ANECDOTAL INSTALLATION AND COMMISSIONING PROBLEMS

2.0 RAF Cottesmore

2.1 Background

Figure 1; Dimensioned as drawn on jointing instruction. Outer heatshrink sleeve not shown.

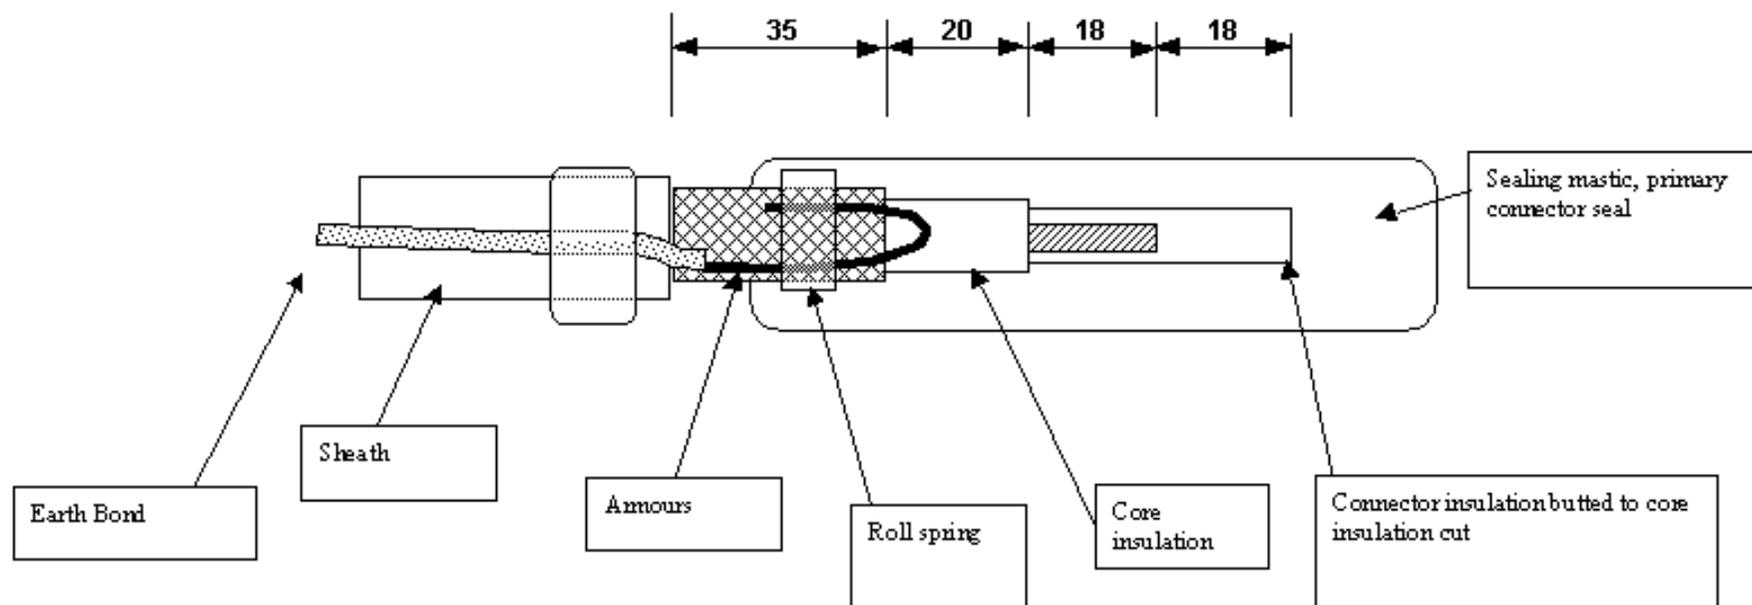
- 2.2.5. Figure 1 shows the joint assembly supplied for the approach lighting system; listed below are the areas of weakness.
- a. The earth bond comes within the primary connector water seal; therefore any water migrating along the earth wire has direct access to the connector if the seal fails.

- b. The assembly of the earth bond described in the jointing instruction can compromise the clearances between the end of the earth bond and the connector.

- c. The joint should be considered 'wet' until the end of the armours, as there is no water blocking under the sheath; therefore any sheath damage will result in water migration along the length of the cable. The dimensions given for the removal of the armours does not allow any margin for error especially coupled with point 2.2.4 b.

- d. A joiner working in the field would generally be expected to work within +/- 5mm, the length of core insulation available for sealing is therefore inadequate. *See Figure 2*

- e. The use of a pre insulated connector makes it unlikely that the sealing mastic would be in contact with the conductor or insulation cut. If the connector is butted to the insulation this leaves an air filled void at the interface between the connector insulation end and the insulation cut which is unlikely to be sealed by the mastic. The dimensions given in the instruction would leave the connector butted to the insulation, although the drawing shows a gap.

Figure 2. Drawing showing 5 mm error to two dimensions.

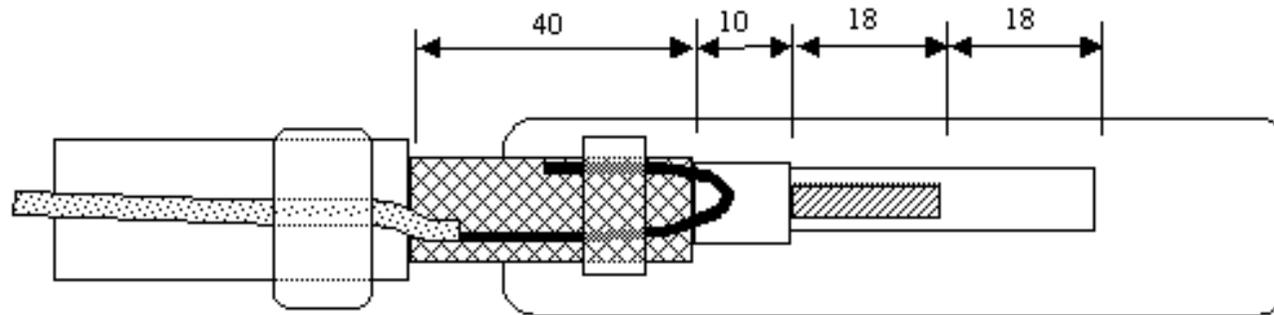
On the above drawing the sheath has been cut back 5 mm short and the armours 5 mm long, this reduces the insulation cut back to 10 mm due to the need to fit the connector equidistant either side of the centreline. The requirement to bend the earth wire back and incorporate it into the spring will further reduce the length of primary insulation available for sealing. Although the instruction specifies the spring position 15 mm from the sheath cut it is most likely to be fitted at the end of the armour cut. In the above case there would only be approximately 5 mm of primary insulation available for sealing after the bend in the earth wires.

Figure 3. Joint assembly ,Figure 2, shown in profile.

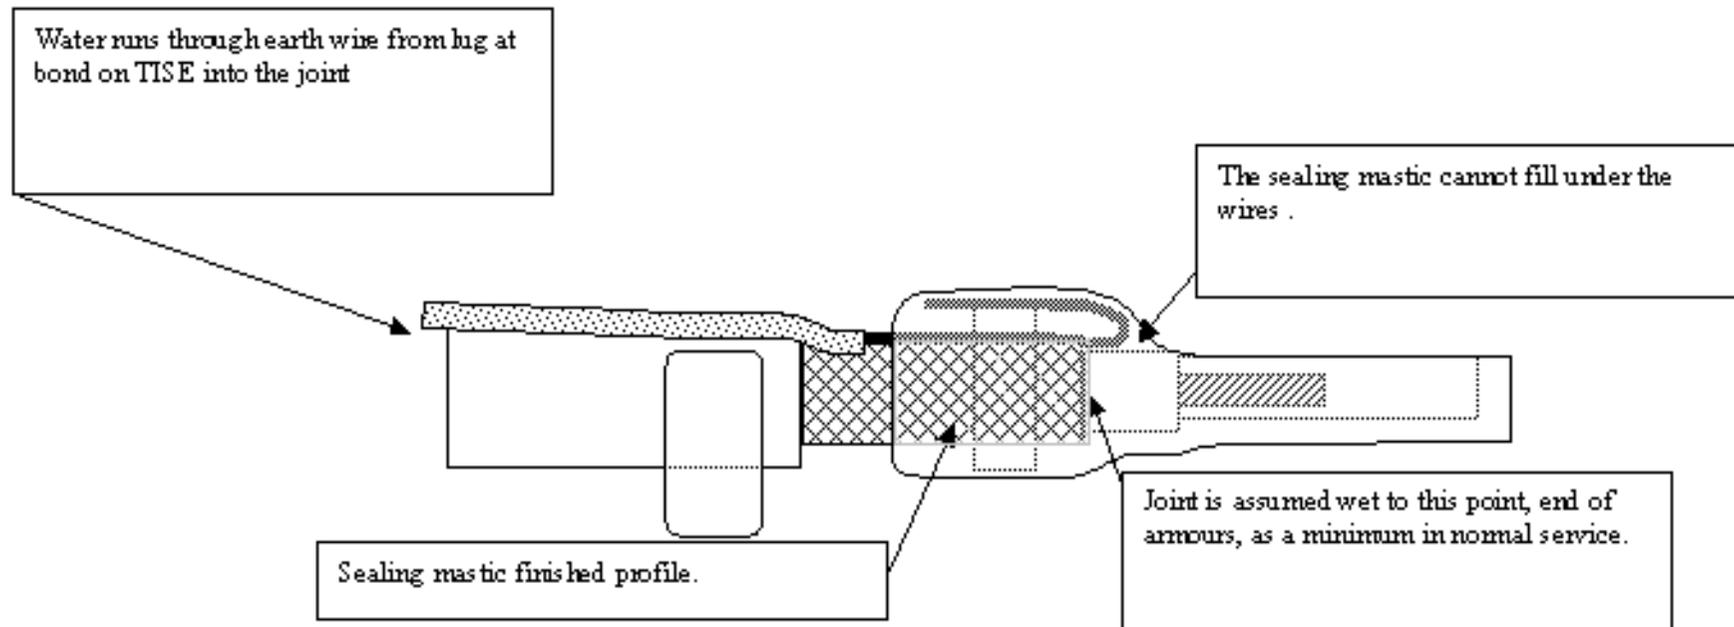
- f. The use of stranded earth wire for the external bond creates a 'pipe' to the inside of the joint. If the external end of the earth wire is not sealed any water in the ground will be drawn into the joint. *See point 2.2.4 a and Figure 3.*

The outer heatshrink sleeve will follow the same profile as shown for the mastic at the end of the earth wire. The sealing mastic will not seal the earth wires nor will it seal onto the primary insulation under the bend in the wires. As well as water migrating along the earth wire into the joint, any sheath damage will result in water migrating to the end of the armours. The bond of the sealing mastic to the primary insulation will be relatively weak in the first 5 mm after earth bond, as the recovery of the heatshrink outer will follow a catenary, the low pressure seal coupled with load cycling will not withstand water at 1 m head for very long.

Picture of connector showing no evidence of black sealant and outer sheath intact at insulation cut.

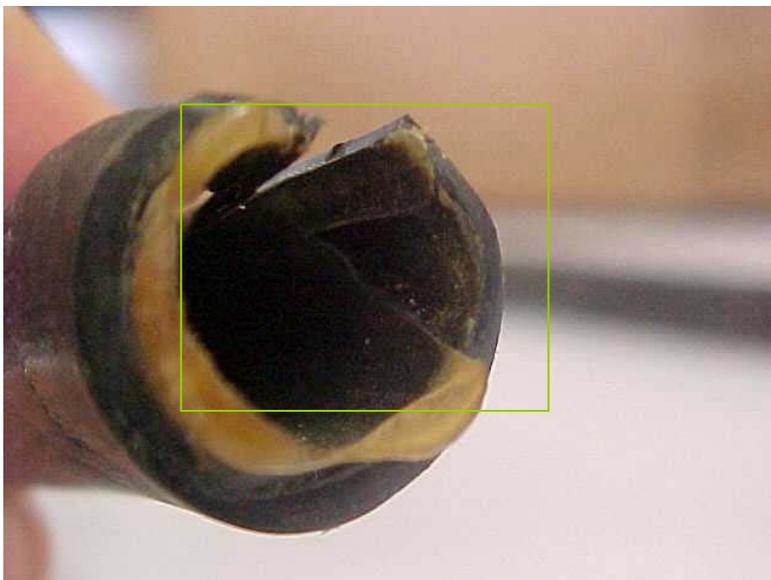
- 2.2.3. Examination of the joints returned with the TISE's from AWE showed that they had not been made in accordance with the manufacture's instruction. The black sealing mastic had not been applied to the connector/primary insulation. Therefore any water under the sheath of the primary tails due to a faulty bonding joint would have immediate contact with the conductor.

Picture showing hot melt adhesive that has not flowed, in green square.

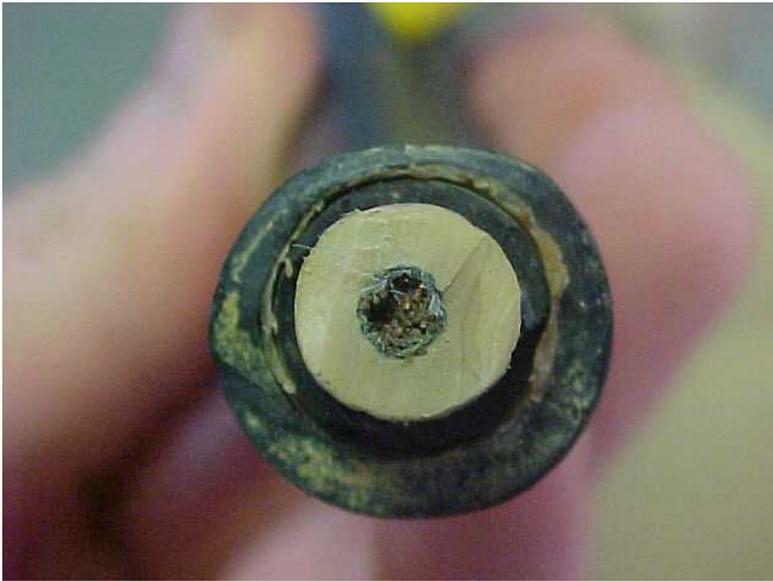
- 2.2.4. It was also noted that the outer protection heat shrink had not been evenly shrunk. One side of the tube was fully recovered while the other side showed minimal to zero recovery. This can only be attributed to a lack of heat and therefore the hot melt adhesive would not have activated. (See photographs appendix 1). On one of the returned joints the outer sheath had not been removed and had been cut flush with the insulation removal position.
